Re: **Mei (DS 19-128)**  
**Santa Rita 2 SW of 5<sup>th</sup> Avenue**

The following responds to your letter dated August 10, 2020 in preparation for the City of Carmel Planning Commission hearing on this item scheduled for November 10, 2020.

RE: Santa Rita 2 SW of 5<sup>th</sup> – Replanting Plan

Subject:      Geotechnical Report - Addendum No. 1  
                 Stability of Northern Excavation

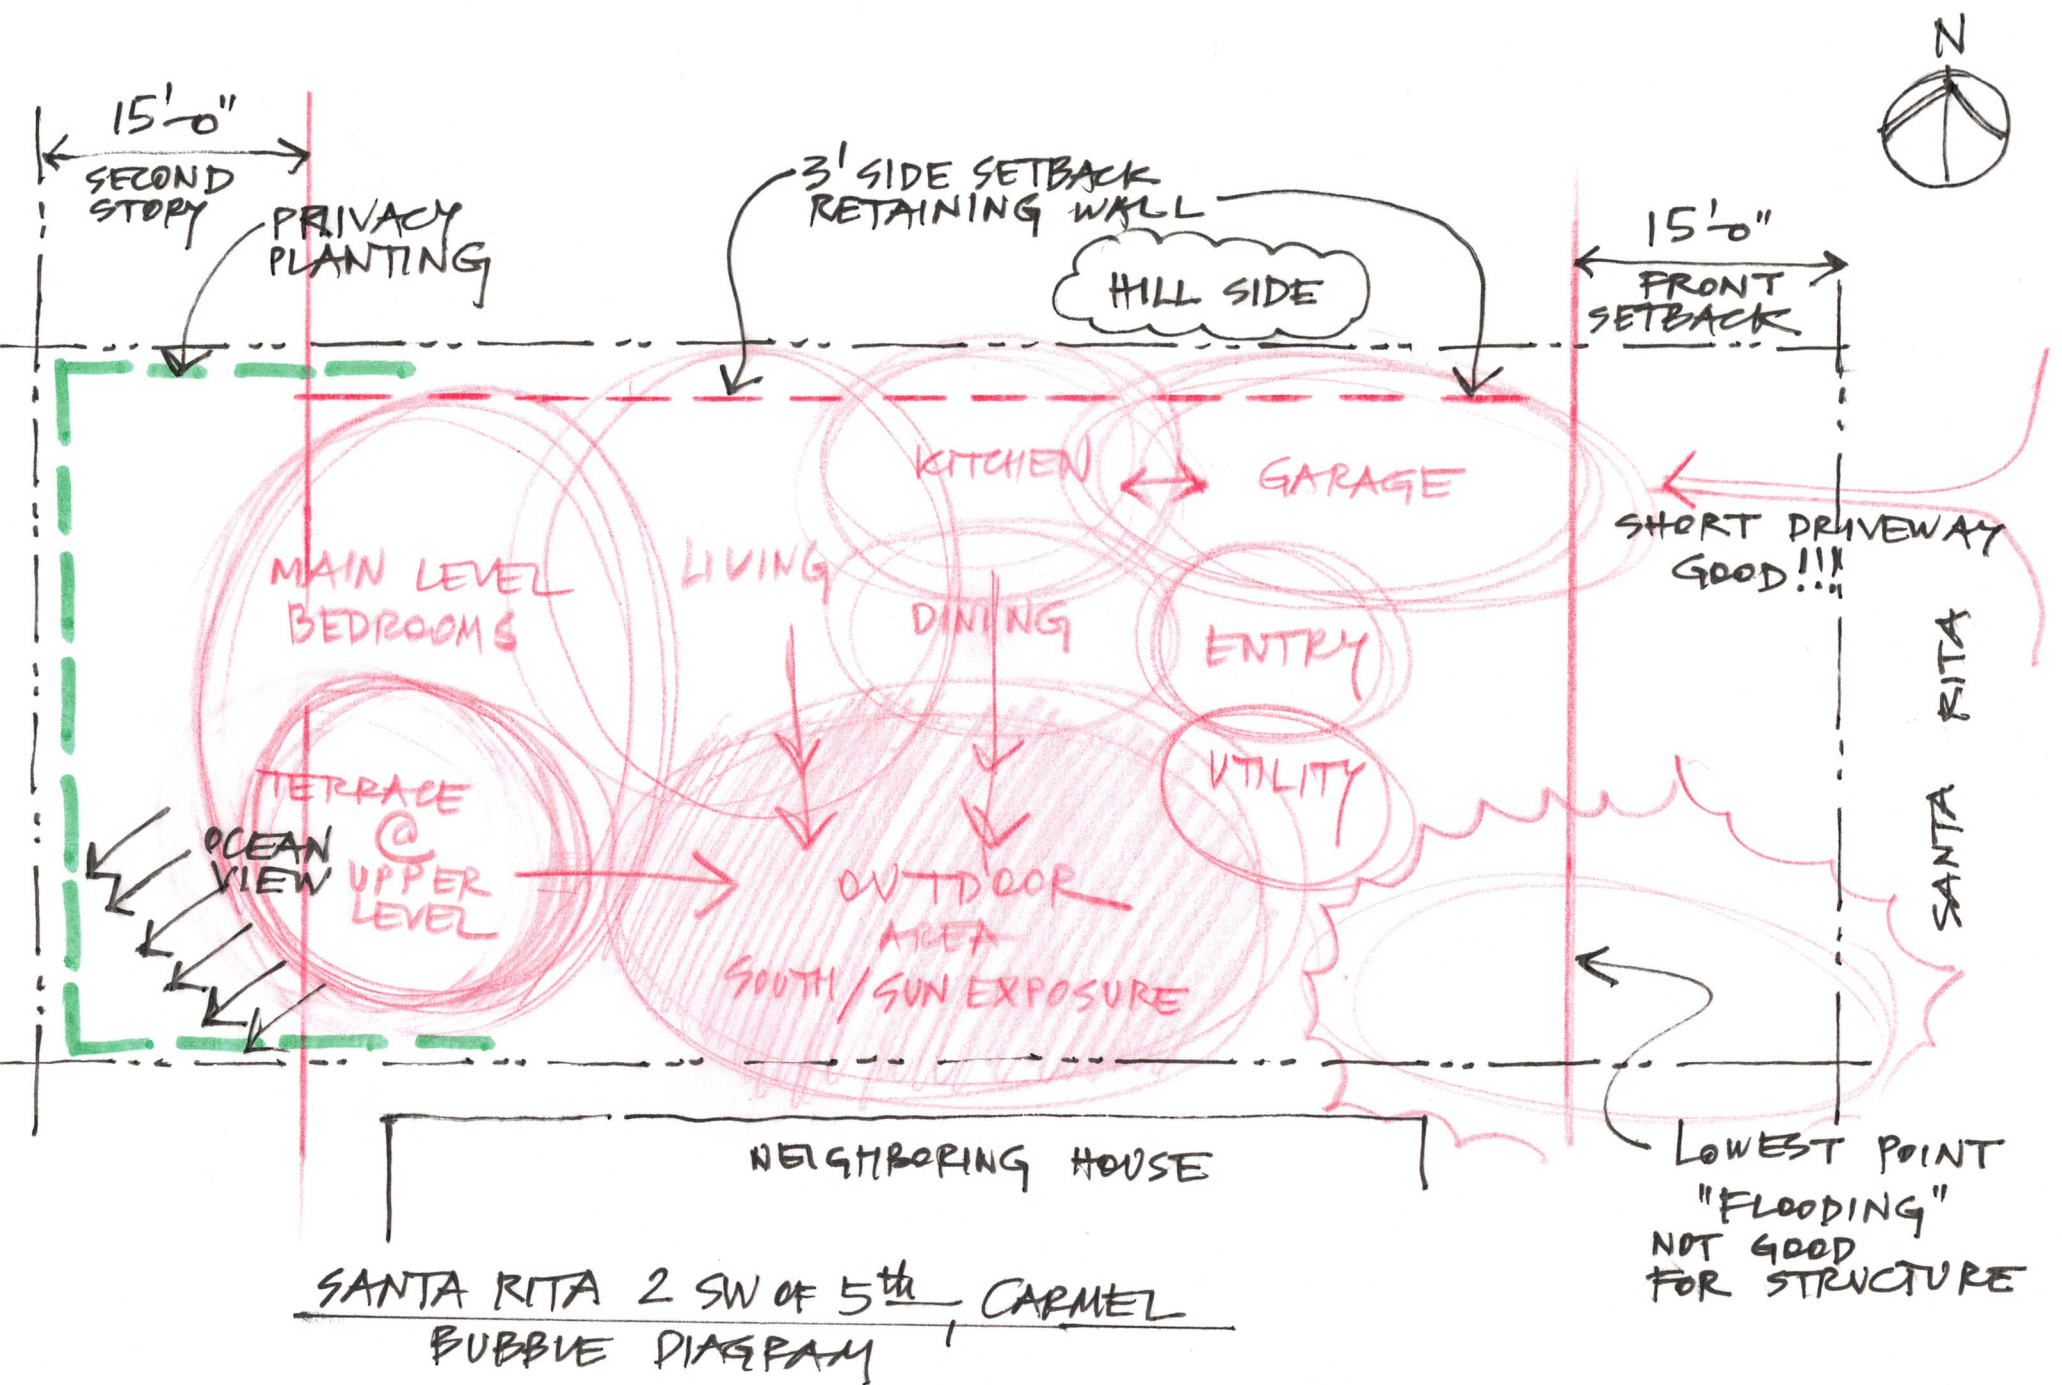
The original house design was primarily focused on a good floor plan layout taking in consideration the above mentioned site constraints. Prior to a concept development a "bubble" diagram was created to establish relationship between interior spaces and outdoor spaces (see Exhibit A) based on the following:

1. The lowest point of the lot (south east corner) is not suitable for any structure due to a storm water drainage potential issue.
2. A retaining wall needs to be constructed at the north side of the property to address existing grade elevation change.

3. Garage and main body of the house need to be located on the north side of the property to provide outdoor area on the south side exposed to the sun light.

4. Garage to be located at front of the property to reduce length of a driveway.
5. Main entry, garage/kitchen/dining area with a powder room/utility room to be located at the front part of the property.

6. Living room to be located in the middle of the house dividing "public area" (kitchen and dining) and private area (bedrooms).
7. Outdoor area to be located in the middle of the lot on the south side, exposed to the sun light, with no (or minimal) noise and privacy insured for all neighboring sites. Easy and direct access to the outdoor area from the kitchen, dining and living rooms, and bedroom.

8. Location of the outdoor ocean view terrace is in the south west corner.
9. Main volume of the house (mass and bulk) to be placed along north part of the property to provide appropriate balance of mass and bulk on the street elevation (see Exhibit B)

While "bubble" diagram provided for retention of existing trees, the trees in this area were not the sole reason for the design as approved. The project was approved with no trees designated for removal. Unfortunately during the construction three large trees were damaged by excavation activities and were required to be removed as a result of the damage.

The design of the home would not have been different even if there had been no trees at the center of the south side of the parcel. The removed trees will be replanted with new large trees in the same location as the removed trees per the City's requirements.

**SHEET**  
**L1**

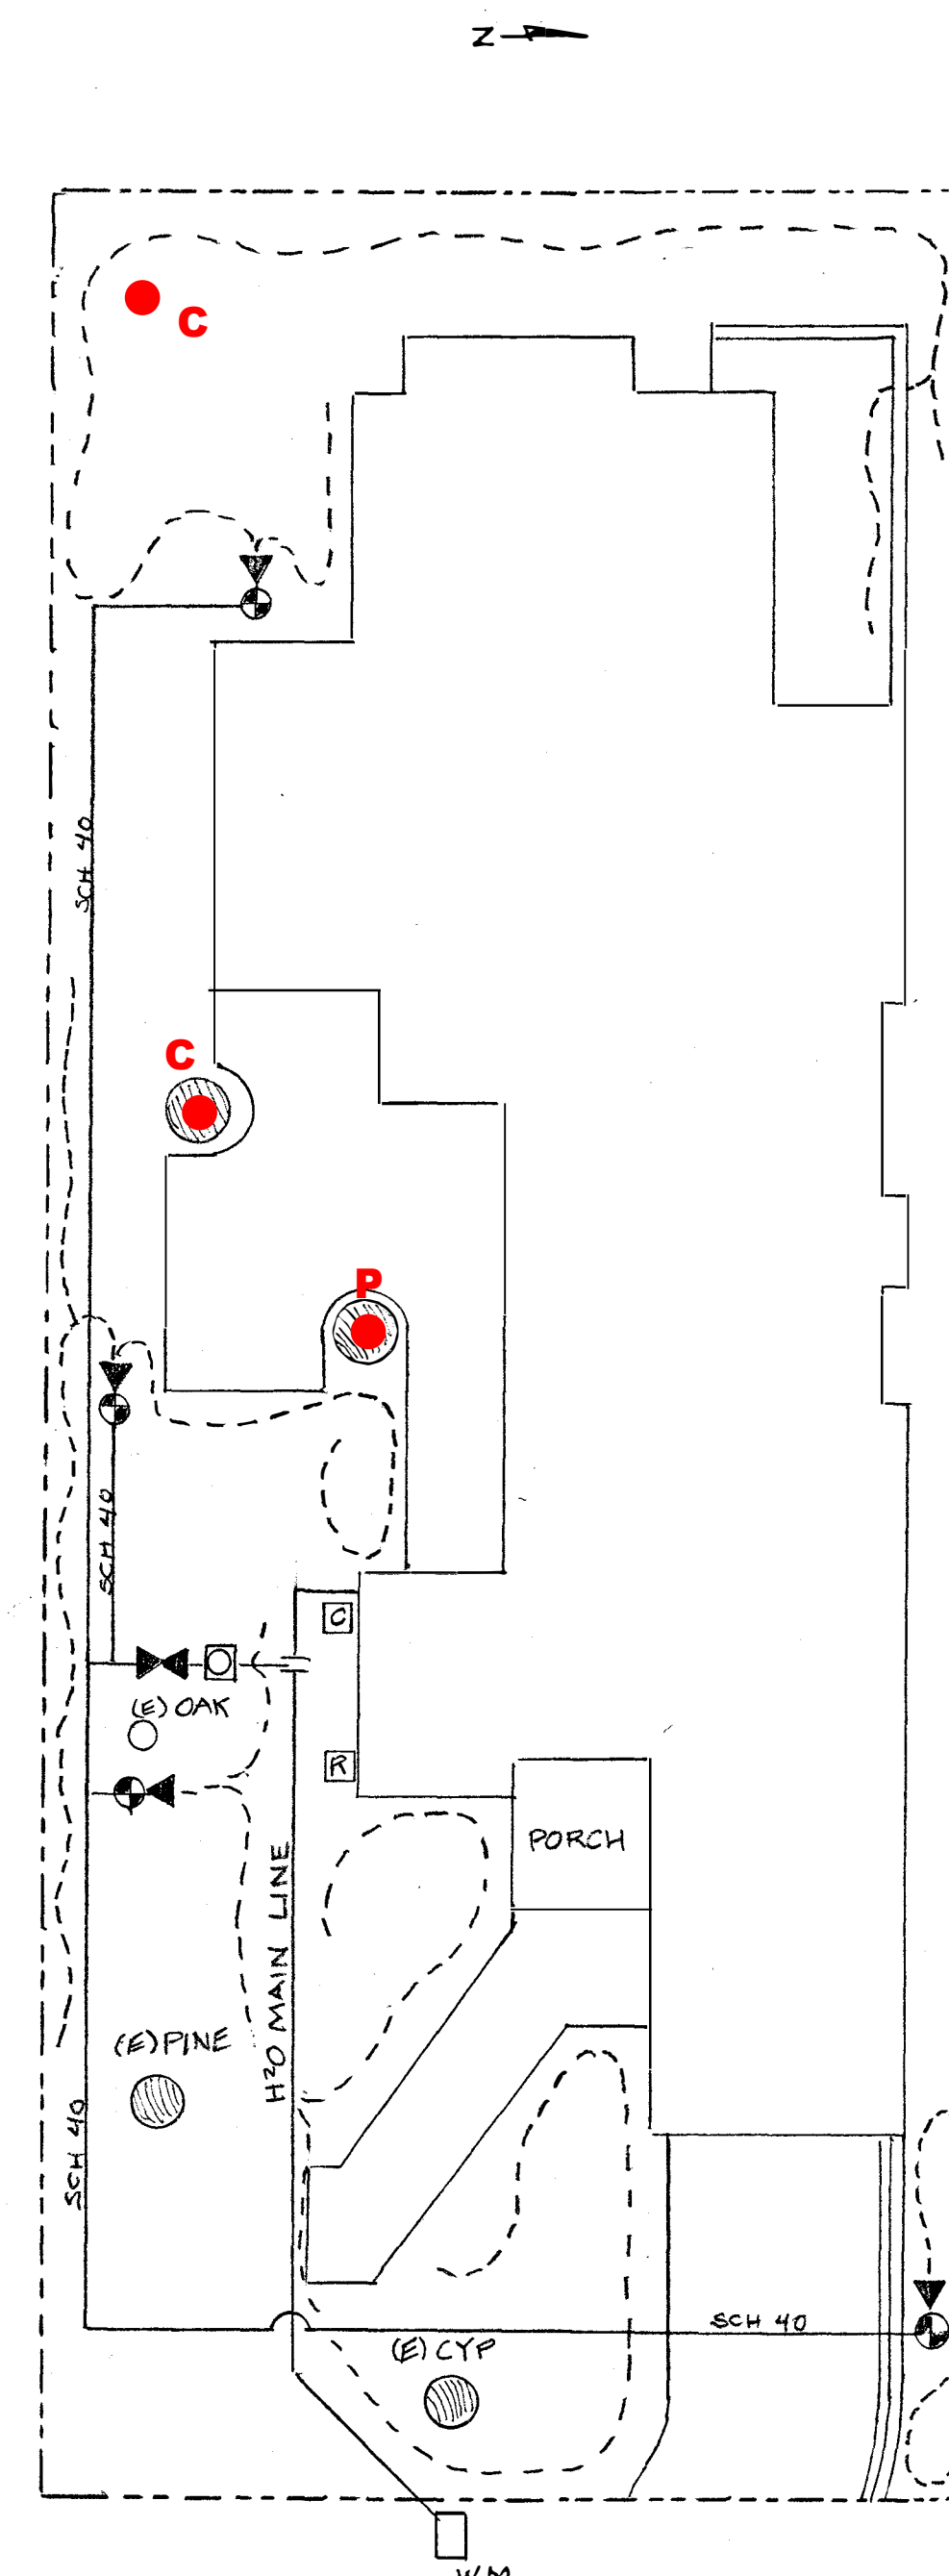
- 3.) Impacts to surrounding neighbors from removal of (3) significant trees: The trees removed did not contribute to screening for any neighboring parcels, however it is recommended by the project arborist that (3) large boxed trees be planted in lieu of smaller alternatives to more expeditiously replace the lost canopies (See attached arborist recommendations & plan). Two new large boxed trees will be planted in the southern courtyard in substantially the same location as the (2) trees removed from this parcel, to promote the replacement of a similar canopy to the southern parcel. Removal of the (3) trees would not have impacted the western neighbor, but the plan continues to include a hedge and expanding fencing to the west, as well as now one of the new boxed trees for replacement. Our office is also working with the neighbor to the north to address the tree lost from their property and to satisfy their requests for additional items.

You recently contacted me about the replanting on the property located at 5 SW of 2<sup>nd</sup>, Carmel by the Sea, CA 92923. We discussed replanting be with larger mature trees for an immediate impact in restoring the urban forest. Replanting with either 36-inch or 48-inch box trees will create an immediate forested atmosphere and help restore the overstory trees that were removed. For replacement of the trees removed, I recommend two (2) Monterey pines and one (1) Monterey cypress. Putting two (2) trees back where they were removed (one (1) pine and one (1) cypress) and adding an addition pine in the southwest corner of the where space is available, and it will not interfere with utilities.

**Replacement trees are marked in red dots. Trees shall be 36 - 48 inch boxes for immediate effect and be installed where trees were removed. An additional tree shall be installed in the southwest corner.**
